THE CITY OF SAN DIEGO

ENVIRONMENTAL IMPACT REPORT

Project No. 636444
SCH No. 2021100394

SUBJECT: All Peoples Church: The project consists of the development of a 54,476-square-foot (SF) sanctuary/multi-purpose building (under one roof) and a 71,010 SF two-level parking garage (367 parking spaces). The project site is a 5.99-acre parcel located at the northeast corner of Interstate 8 (I-8) and College Avenue of the Navajo Community Plan area. The vacant site is outside the City's Multiple Species Conservation Program (MSCP) preserve, the Multi-habitat Planning Area. The proposed project would include a 900-seat church with accessory uses (i.e., Sunday school classrooms, offices, and a multipurpose room/gym), a parking structure and surface parking, site improvements, and off-site improvements to College Avenue. Of the 900 seats, 587 seats would be fixed in place, and 3,690 SF would accommodate the remaining non-fixed seats. Congregation gatherings would primarily occur on Sundays; small group activities may occur during the weekdays or on Saturdays. No primary educational school spaces are proposed as part of the project. The project would also include on-site water quality basin

Figure 2-5

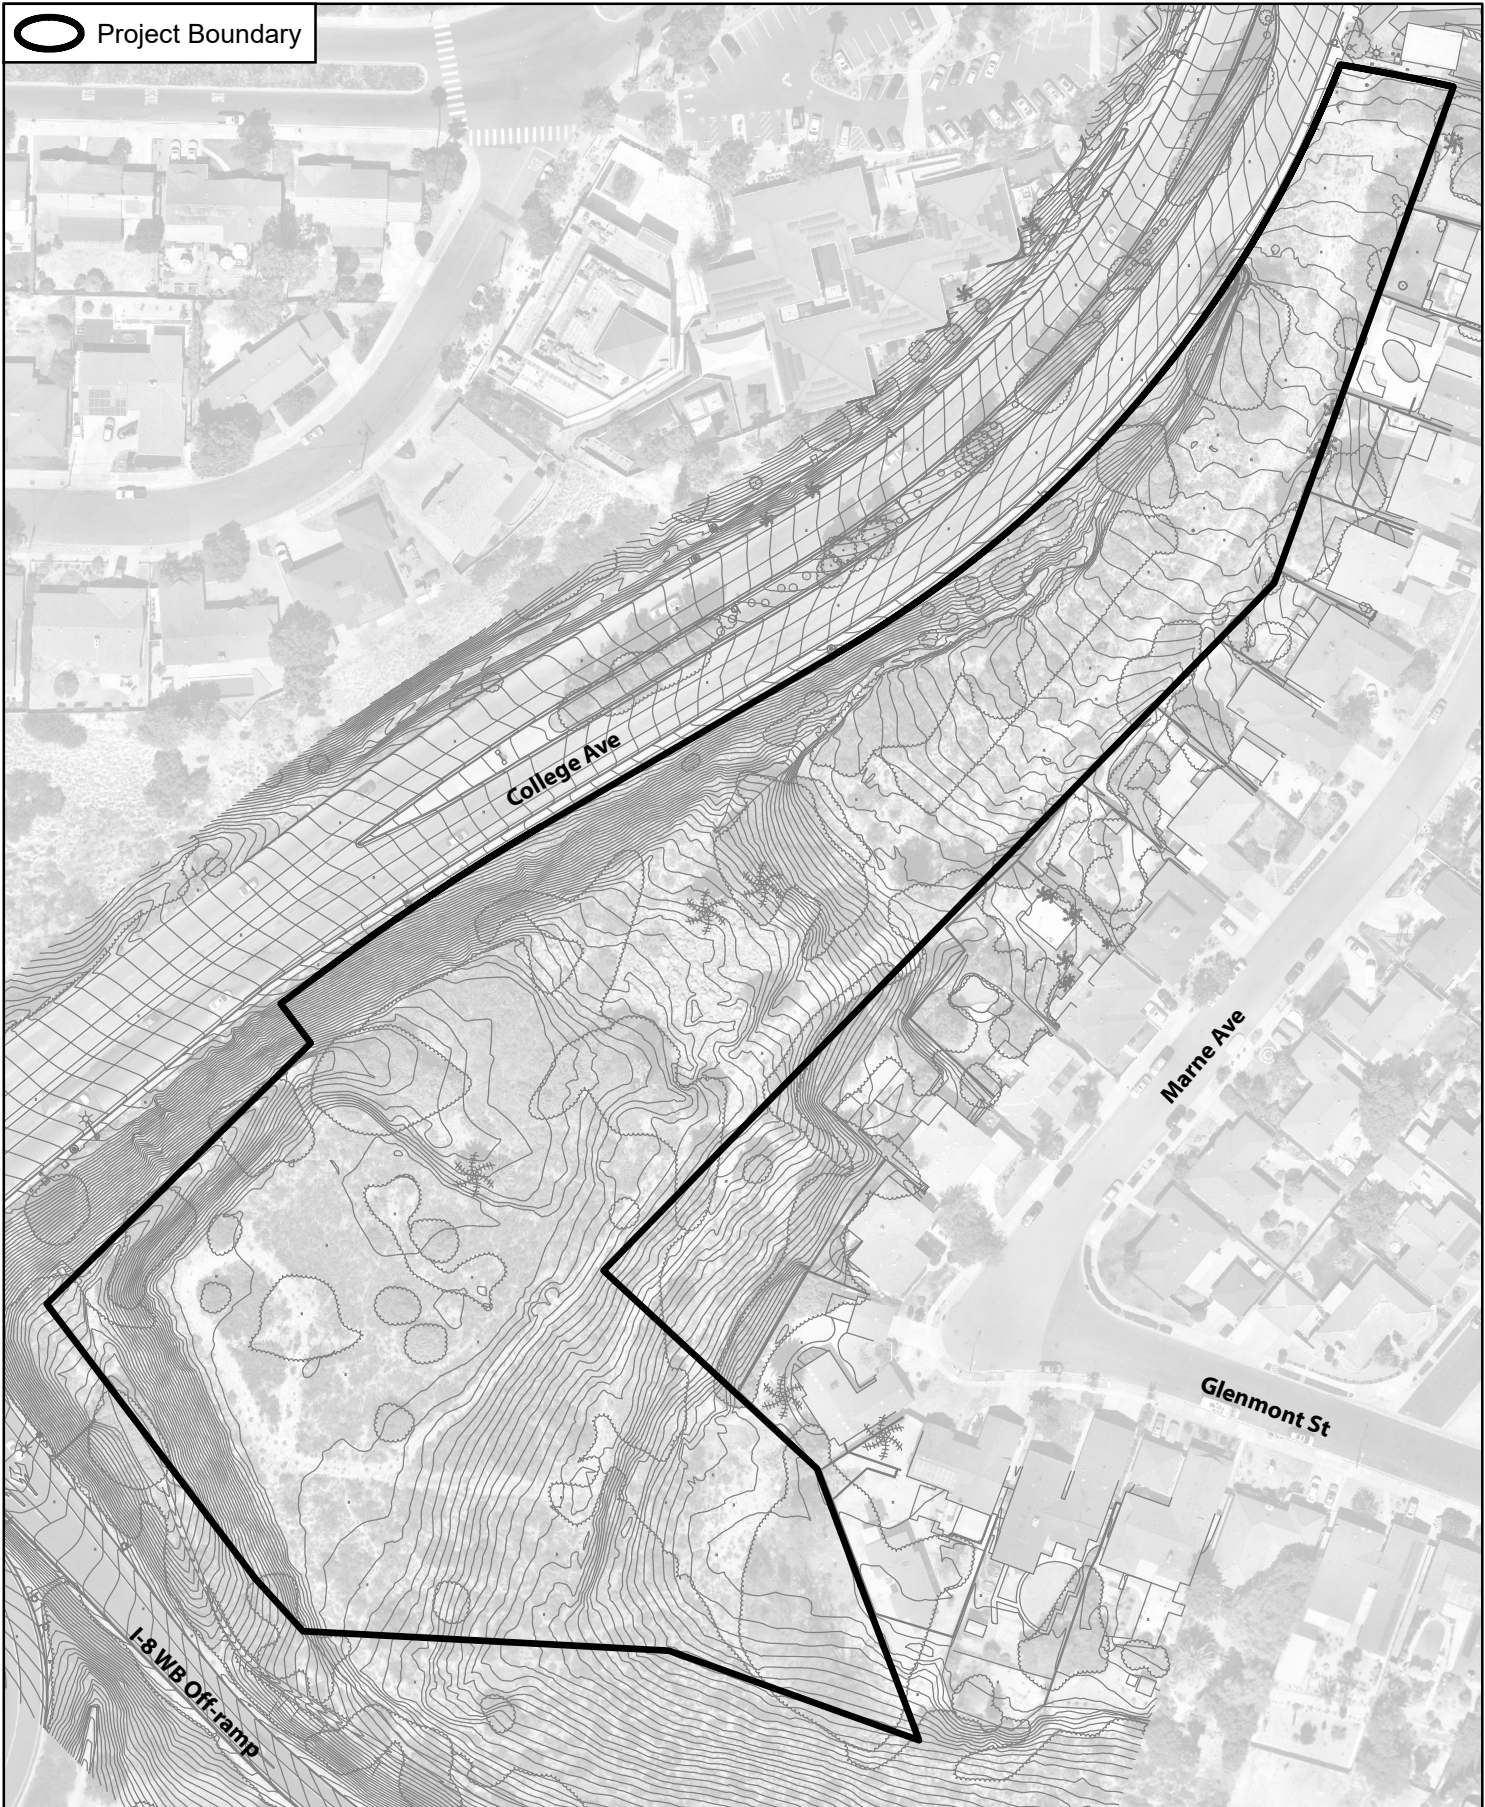
This fact is crystal clear by visually overlaying the Project plan within the black outline of the parcel at full scale as elaborated in the Report onto the Report's own Fig 2.5 Site Picture of the Del Cerro community.
